Marin County Flood Control and Water
Conservation District
**Corte Madera Creek Flood Risk Management
Project, Phase 1**
Final Environmental Impact Report
Volume 1: Comments and Responses to Comments
State Clearinghouse No. 2020080353

**Marin County Flood Control and Water
Conservation District
Corte Madera Creek Flood Risk Management
Project, Phase 1
Final Environmental Impact Report
Volume 1: Comments and Responses to Comments
State Clearinghouse No. 2020080353**

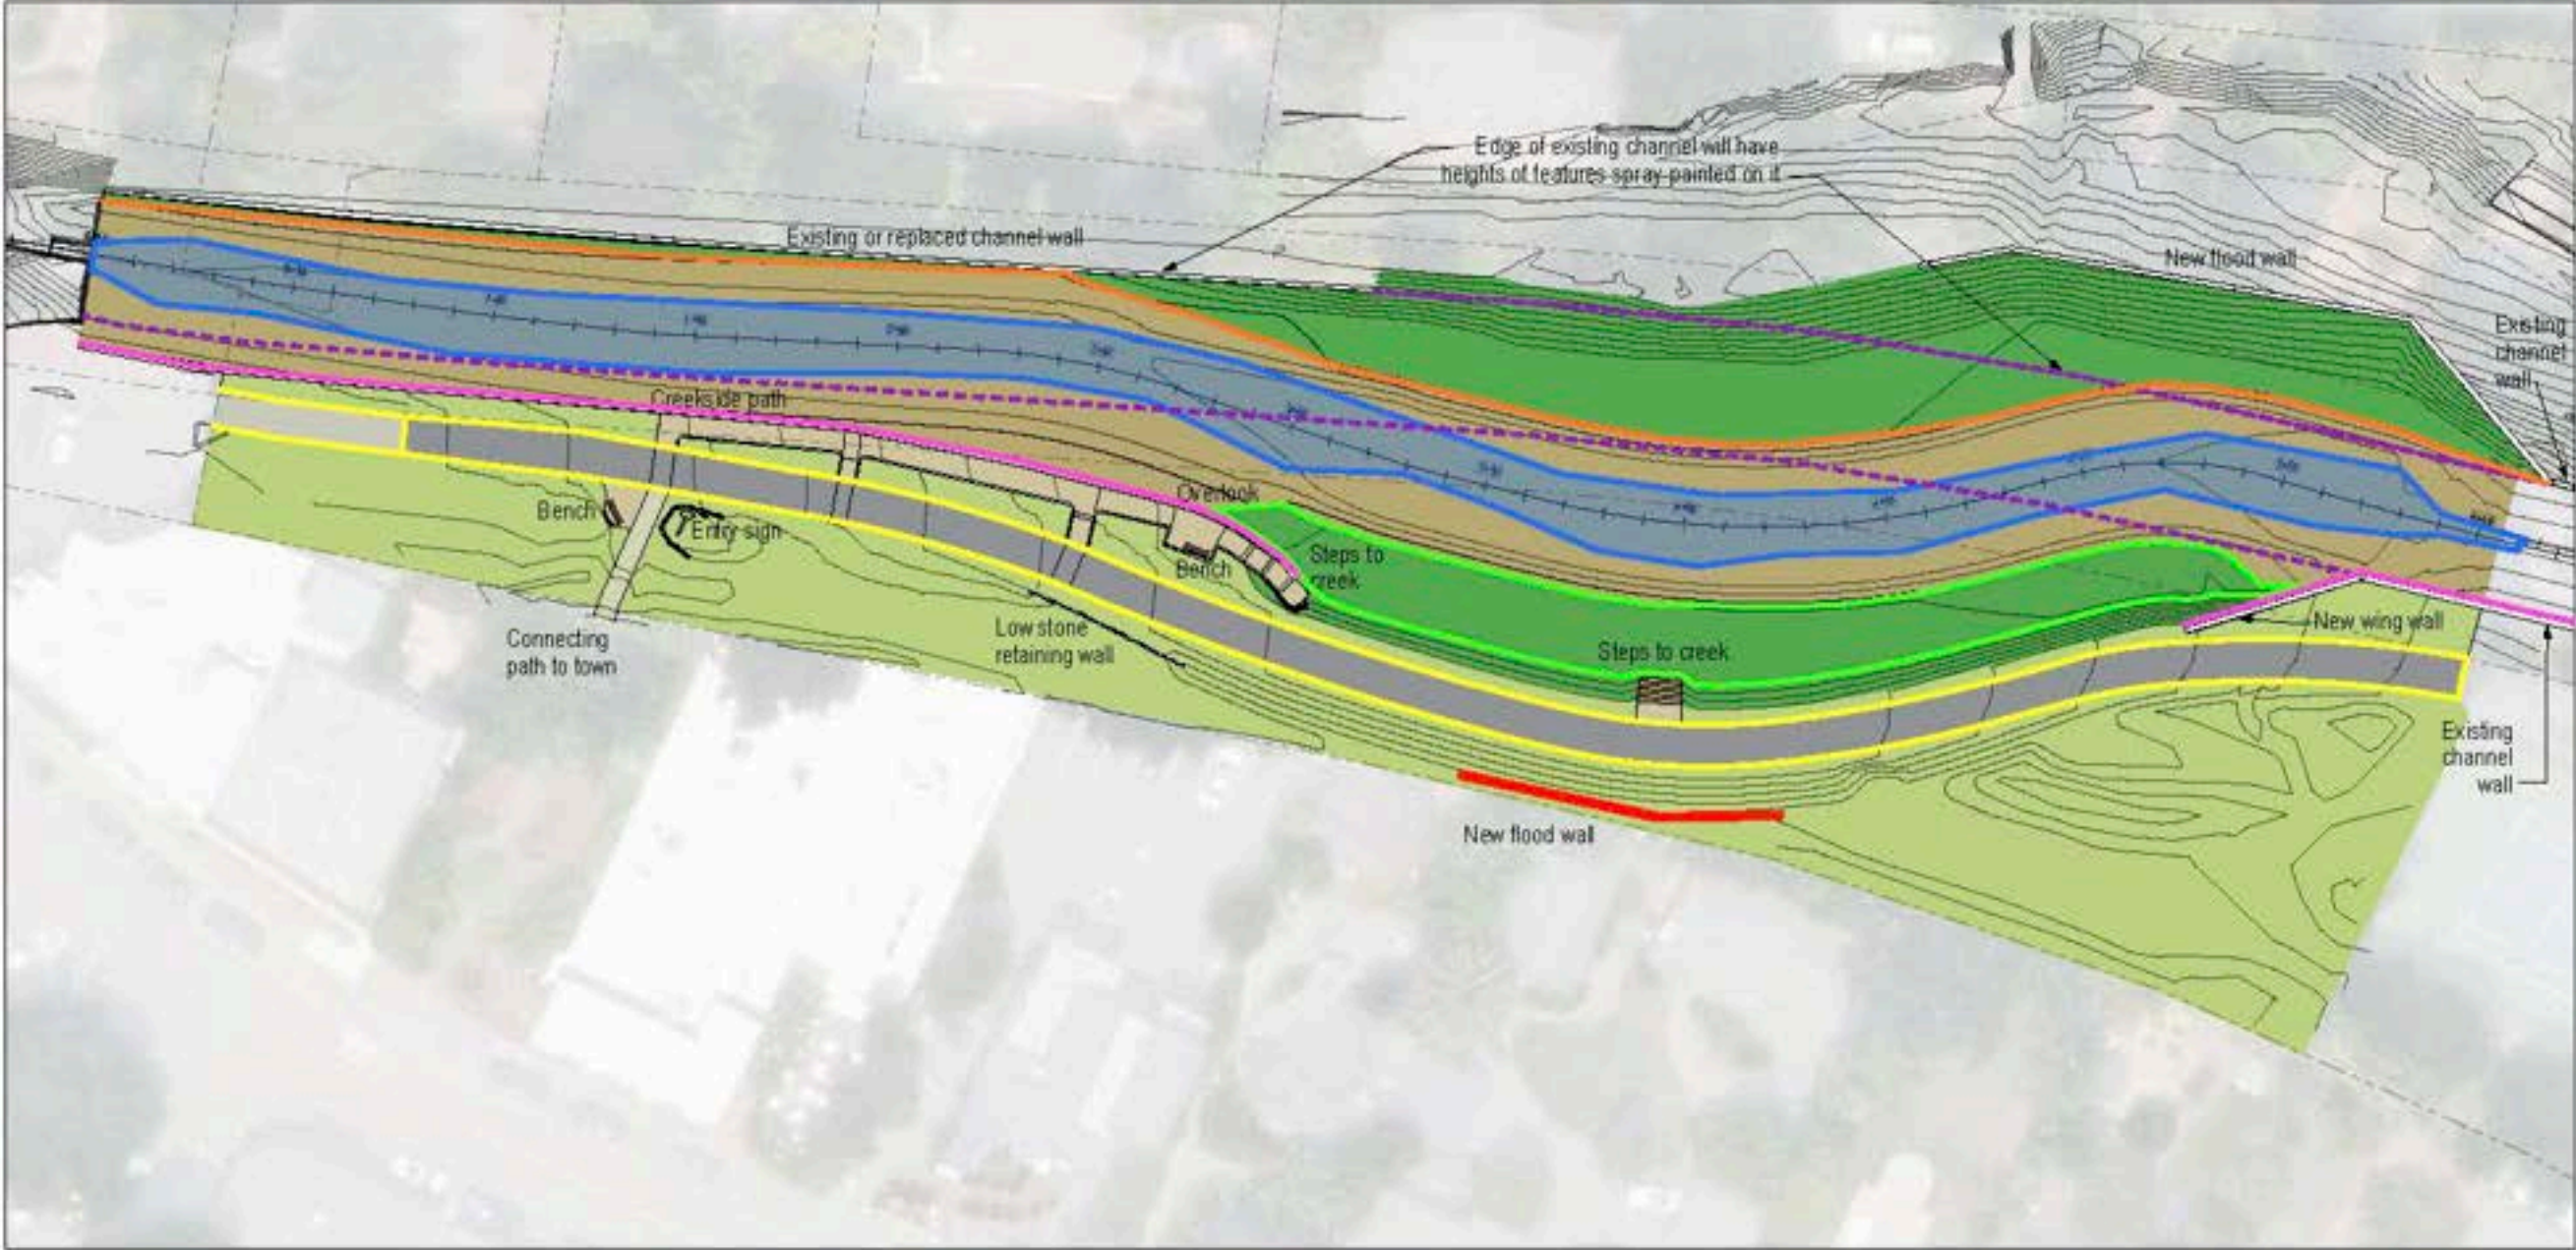
- On page 2-17 figure 2.5-4 should clearly show the existing concrete channel walls on both sides of the channel for ease of reference. A5-8
- On page 2-34 under the section 2.6.4 Grading, the concrete apron at the transition between Unit 3 and Unit 4 should be mentioned and described. A5-9

- A5-8 The commenter states Figure 2.5-4 should clearly show the existing concrete channel walls on both sides of the channel for ease of reference.

Figure 2.5-4 shows the proposed landscape plan. Due to the relocation of the channel and the number of trees that are proposed, the existing concrete channel would obscure the graphic. An additional graphic of the area was prepared for a Town of Ross public workshop in April 2021 and markings were placed throughout the park to assist the public in understanding where the natural channel and proposed project elements would be located. This graphic is provided on the following page.

Figure 2.6-1 Staging, Stockpile, and Temporary Work Areas

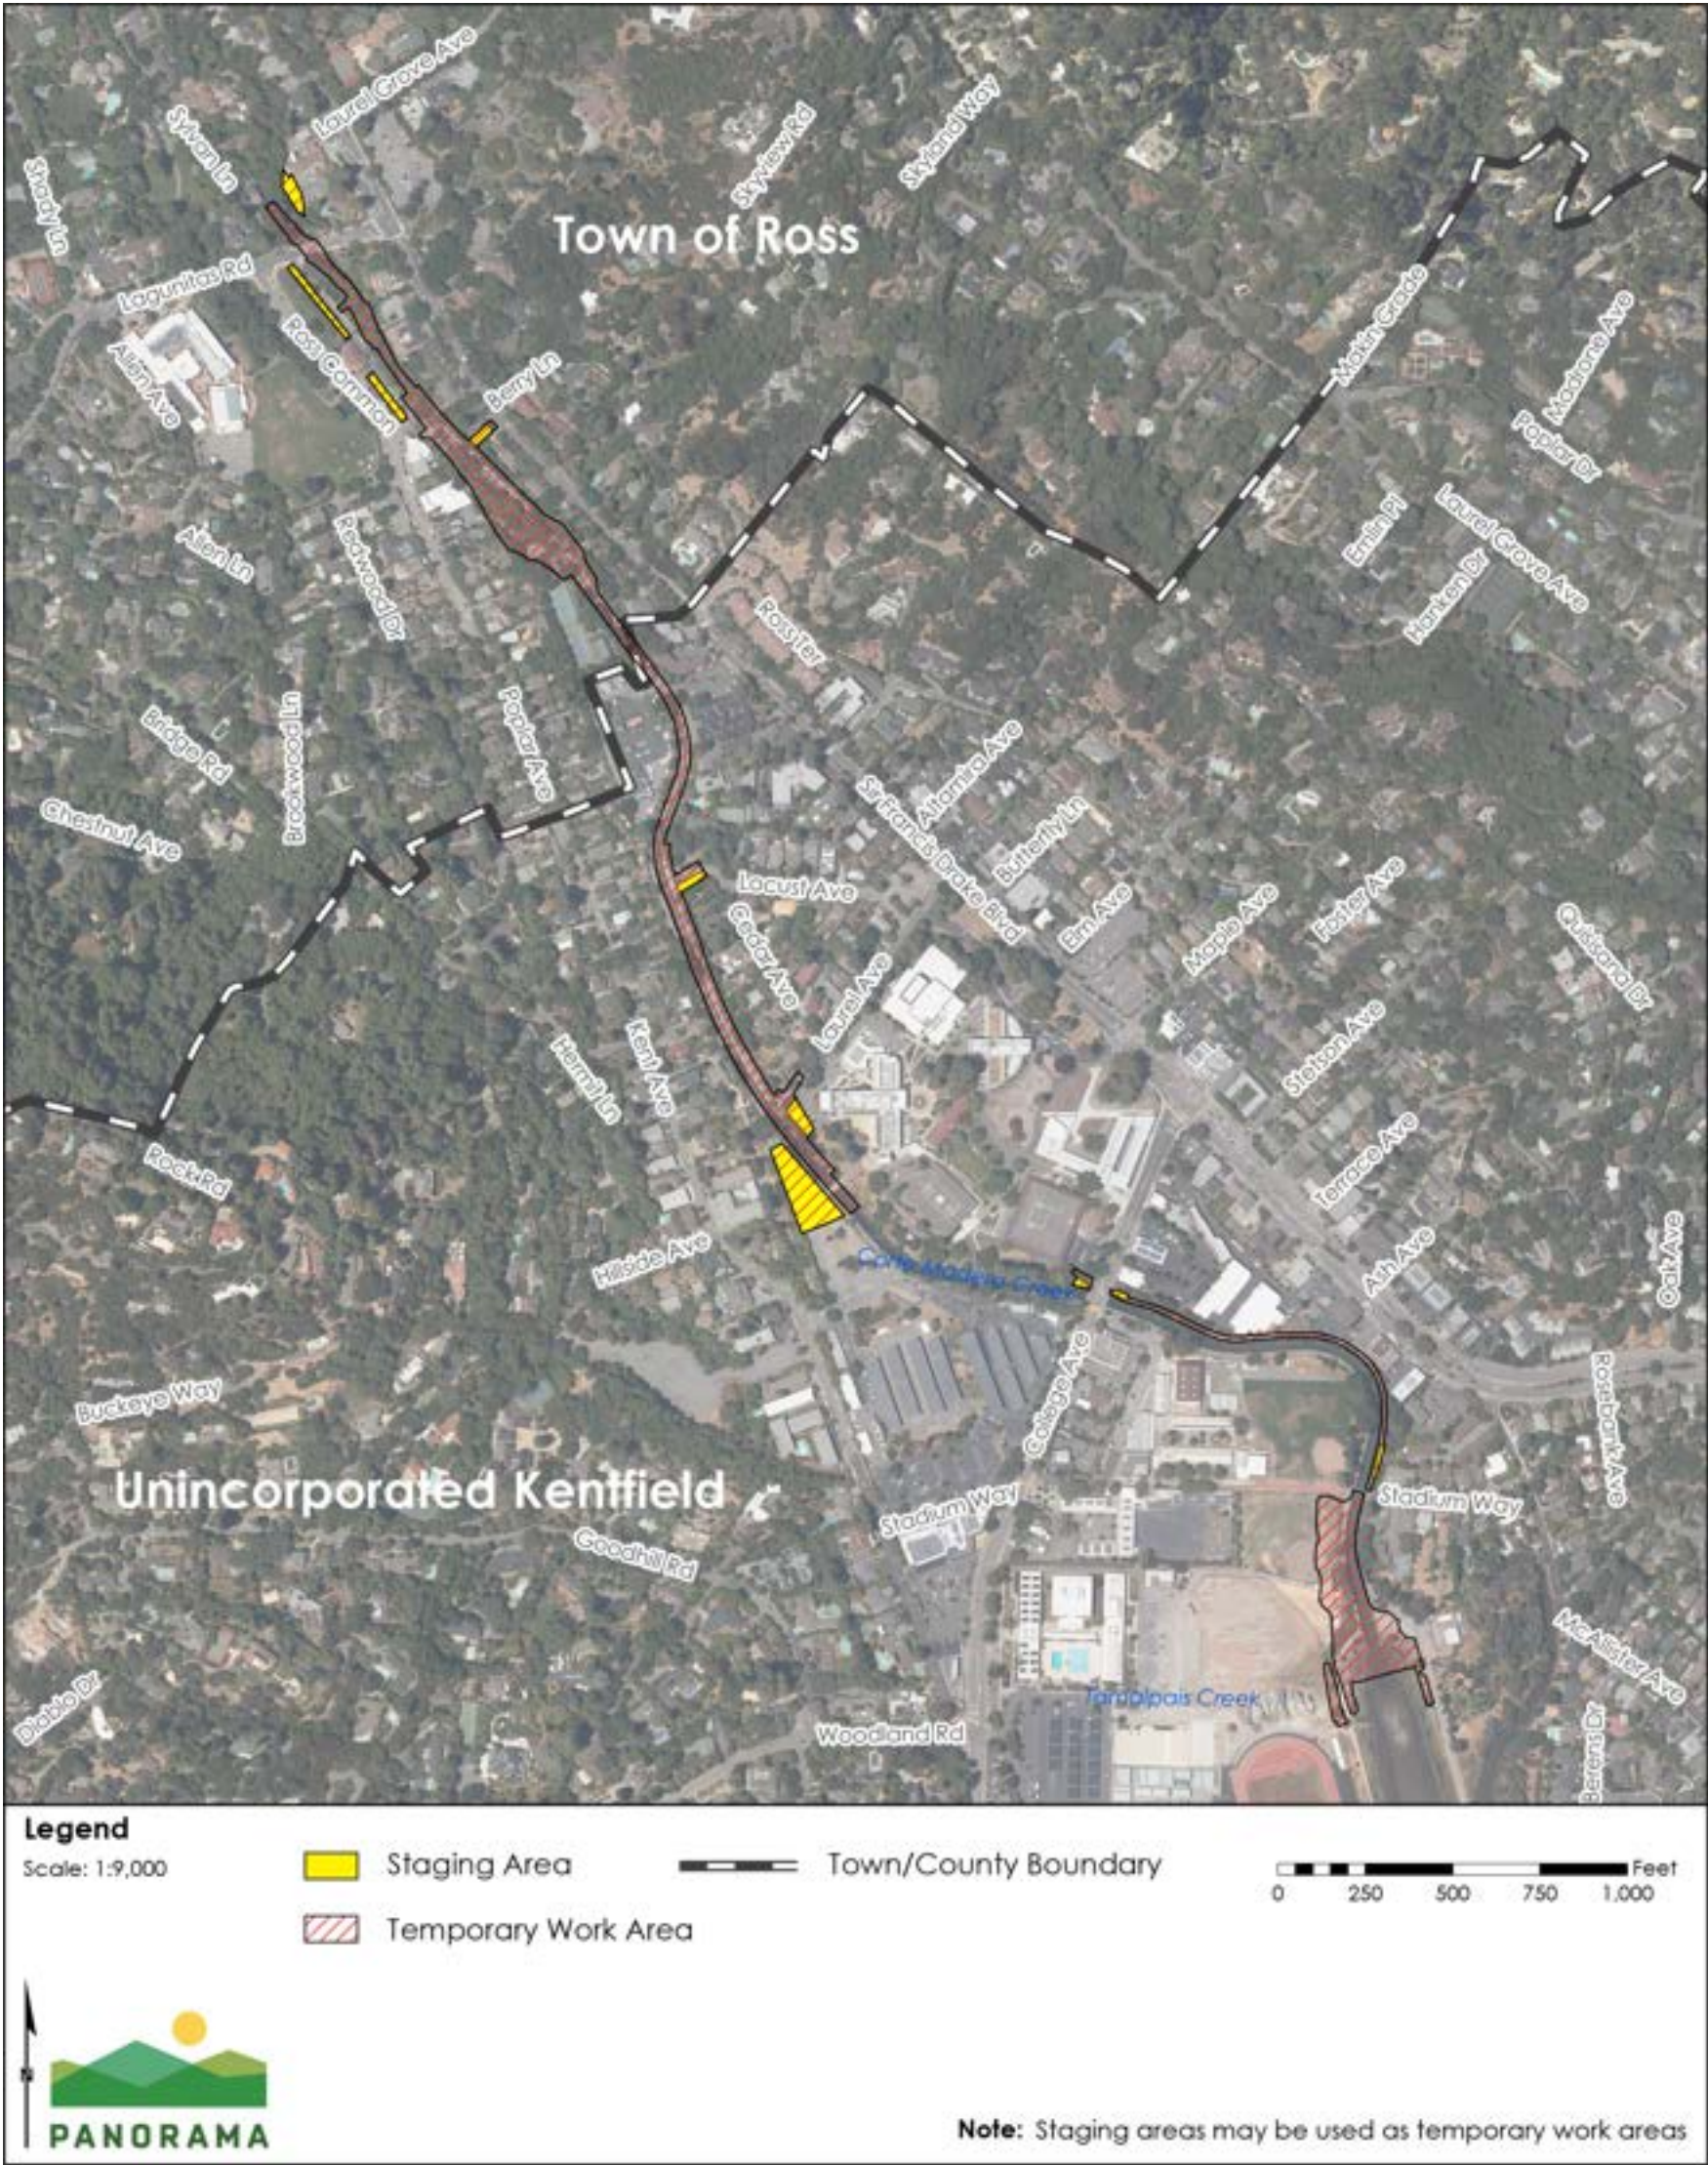
Figure 2.6-1; Figure 3.3-3; Figure 3.9-3 Remove staging area shown in COM project area. See Sheet C17 of 65% design plans for designated staging area.

The staging area located in Parking Lot 9 on college property **Figure 2.6-1** would take away from parking which is already in limited supply at the college and in Kentfield in general. Any use of college property would need to be returned to equal to or better than their current condition.

Figures 2.6-1, 3.3-3, 3.9-3, and 3.15-3 have been revised as follows to show the correct footprint for the Lower College of Marin Project. These maps do not include a staging area at the location of a turn-around for emergency vehicles required by the Kentfield Fire District nor a planted area beyond the multi-use path on the left bank of the creek:

Figures 2.6-1, Figure 3.3-3, and Figure 3.9-3 in the Draft EIR have been revised to remove the staging area shown in the College of Marin Project area as shown in response to B1-25 above.

Refer to response to comment B1-31. Figure 2.6-1 in the Final EIR has been revised to remove the staging area shown in parking lot 9 on college property.
